PLANNING BOARD

Tuesday, February 14, 2023 at 4:30 PM
Remote meeting via Zoom

To: Maggie Stanley, Chair and Members of the Planning Board
From: Austen Torres Davis, Planner
Date: February 10, 2023
Re: Major Site Plan Application – 185 Commercial Street
Project #: PL-002265-2022
Meeting Date: February 14, 2023

Drawing No.
C-3.0

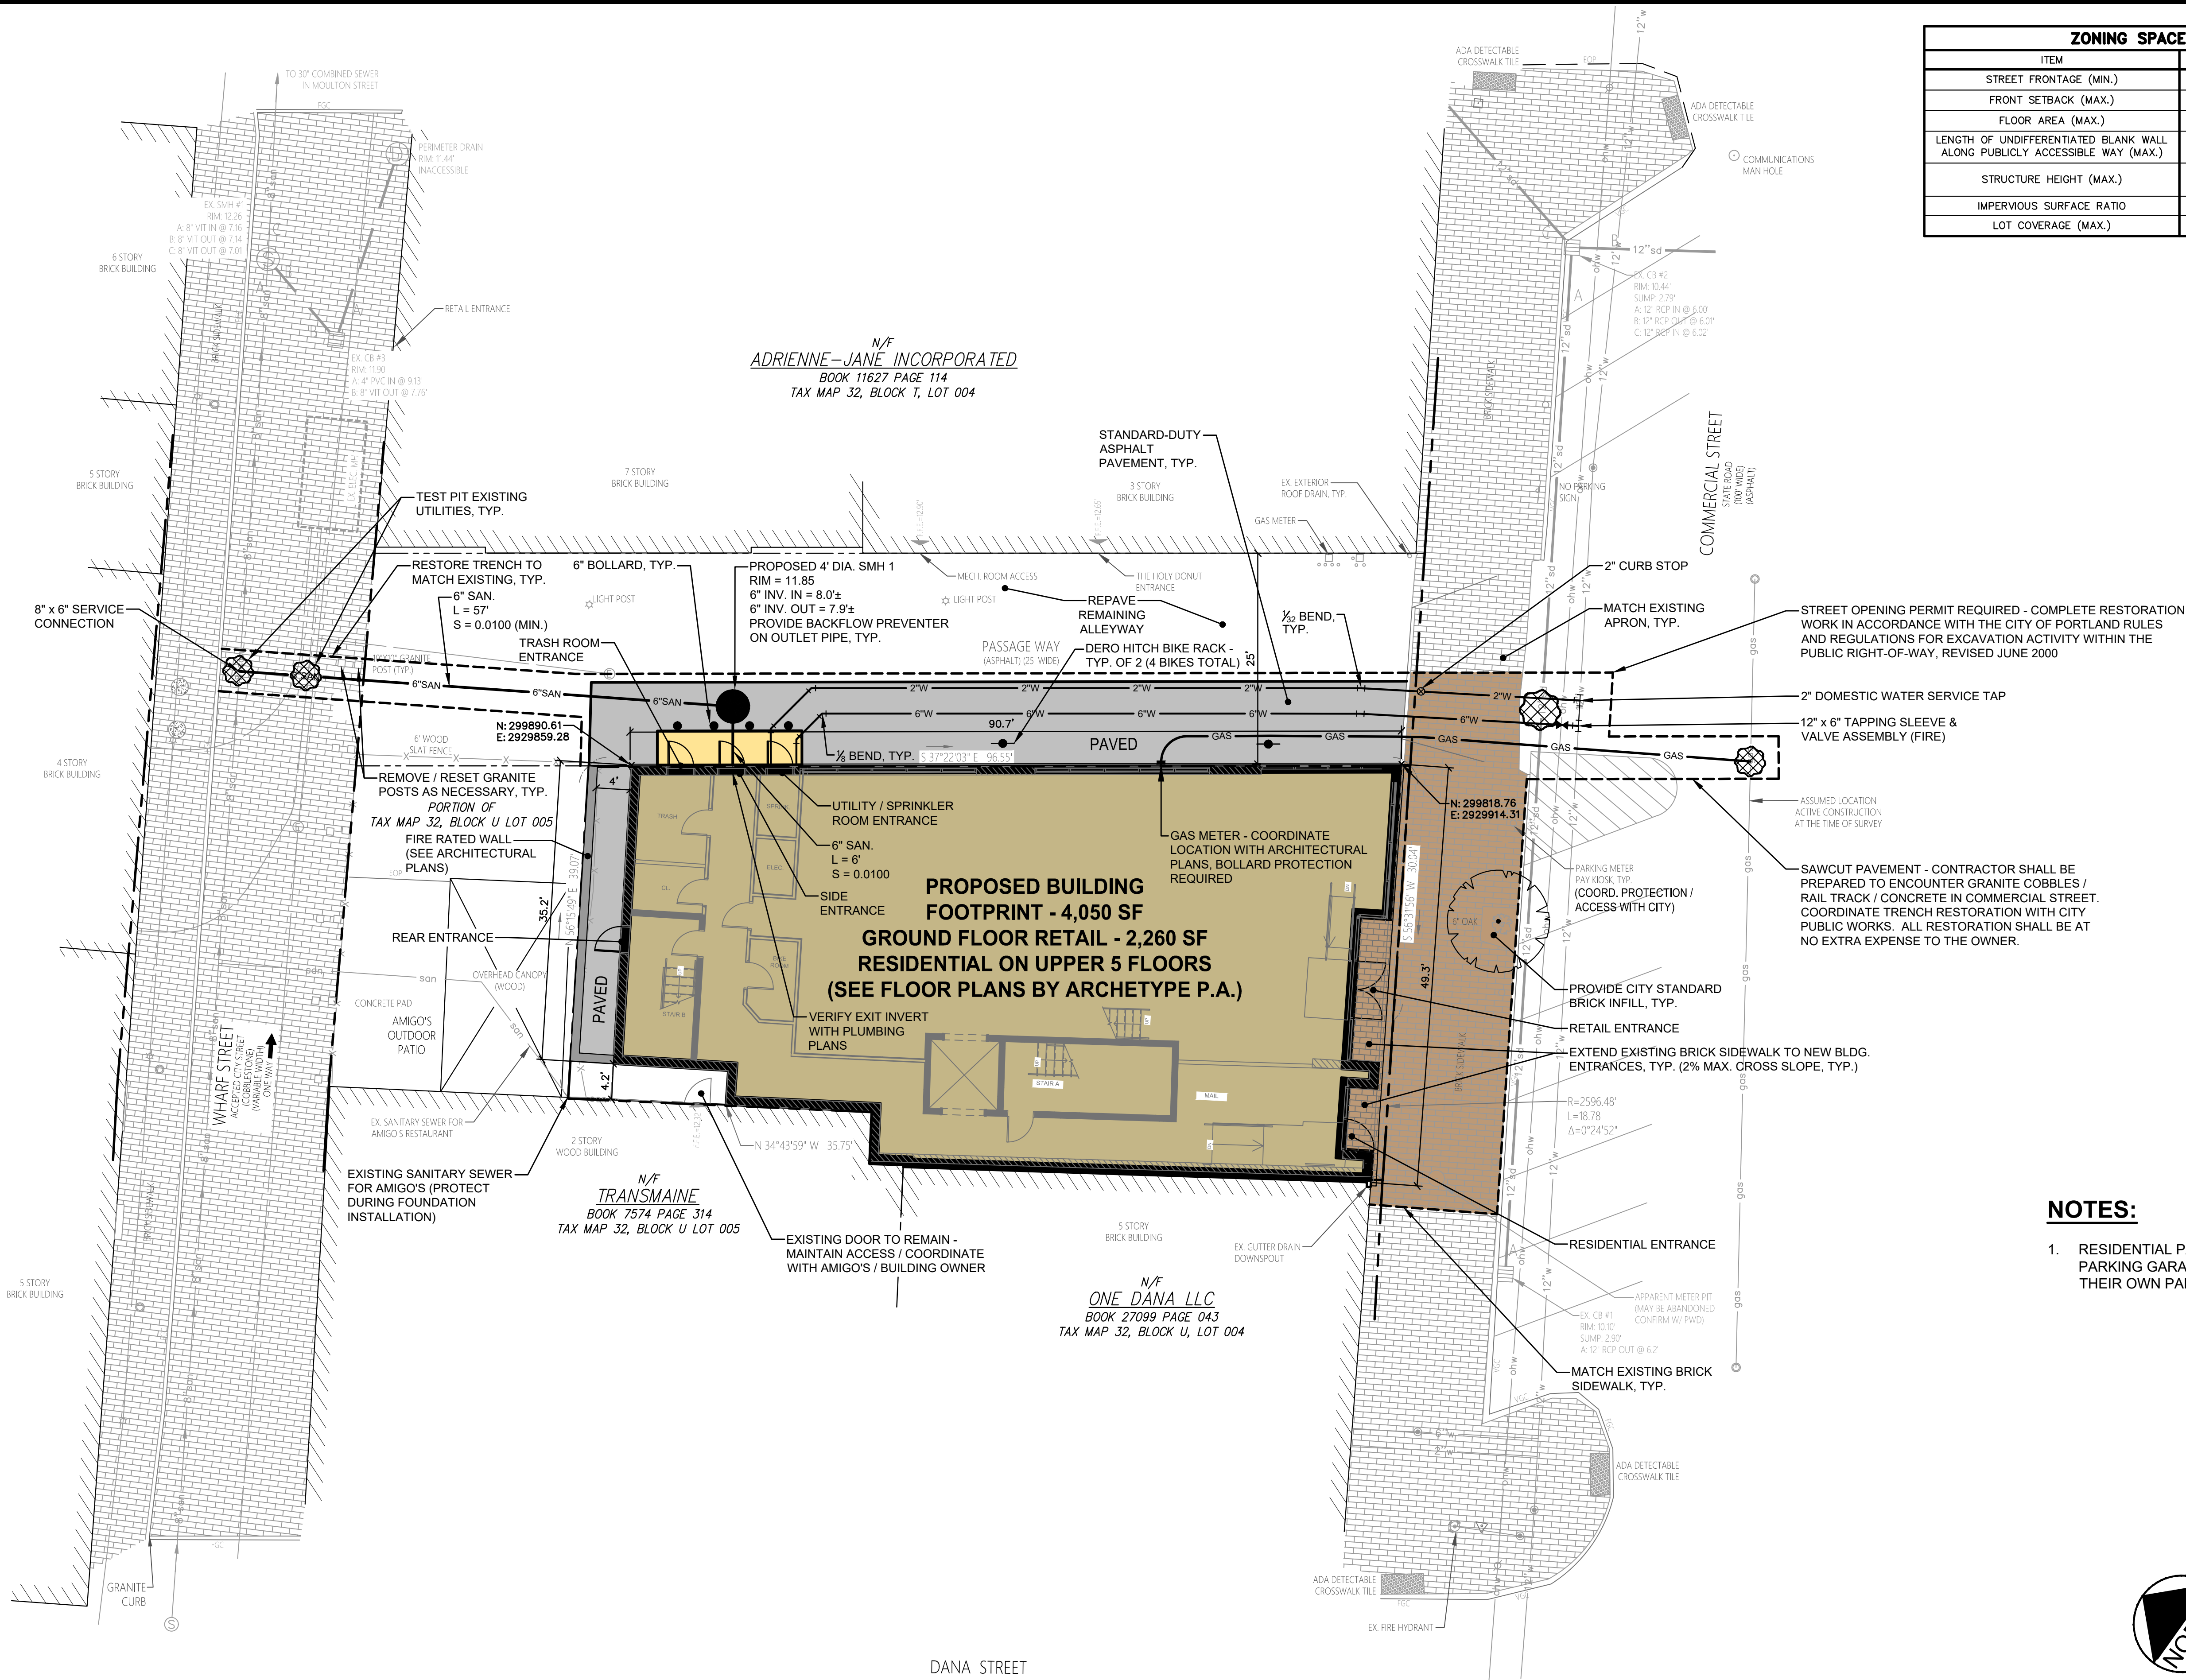
Response: Drawing C-4.0 contains some information on needed erosion controls during construction. Additional Erosion control notes are shown on C-1.1. We intend to provide additional information on the final plans to assure ample information is provided to the contractor.

SHEET 5 OF 25

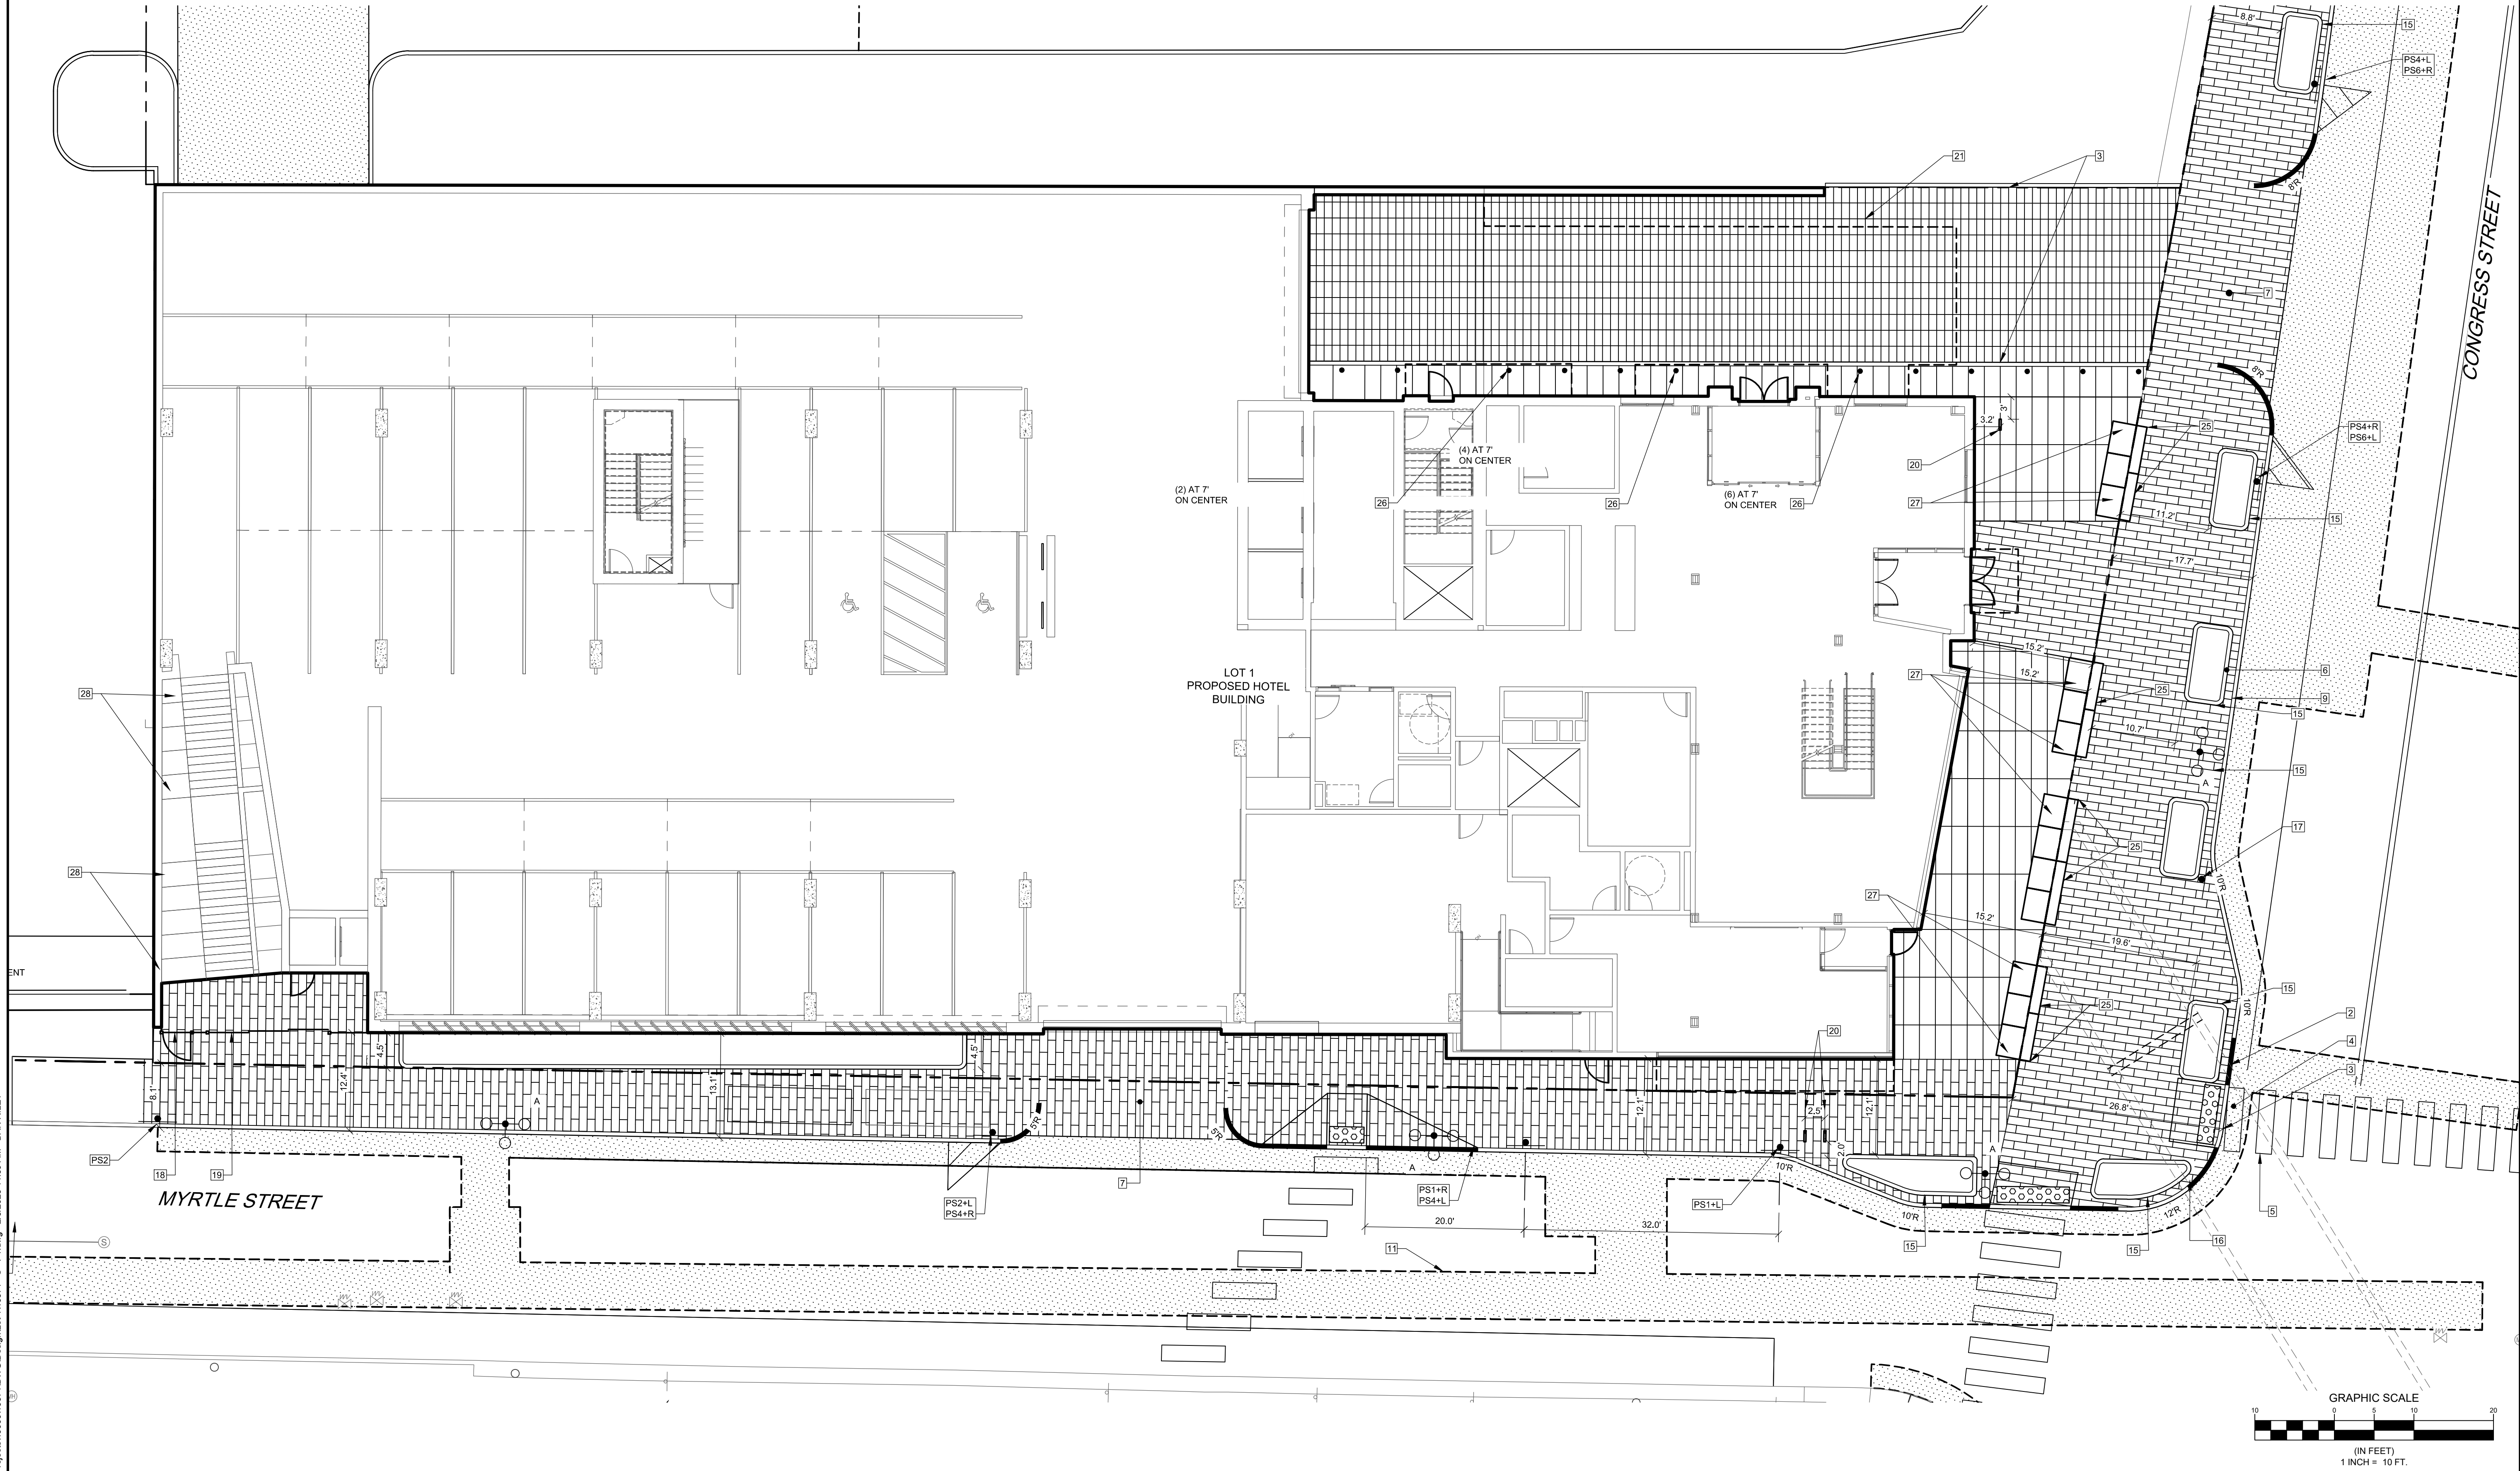
1. The Applicant shall update the site plan set to state that the City will review conditions on Pearl Street post-occupancy and determine the feasibility of on-street parking in a future phase of the MDP, offset the eastbound Congress Street left-turn lane off-set STOP bar by 15 feet, and replace site plan key note 17 on site plan sheet 5 with a metered parking sign (PS6).
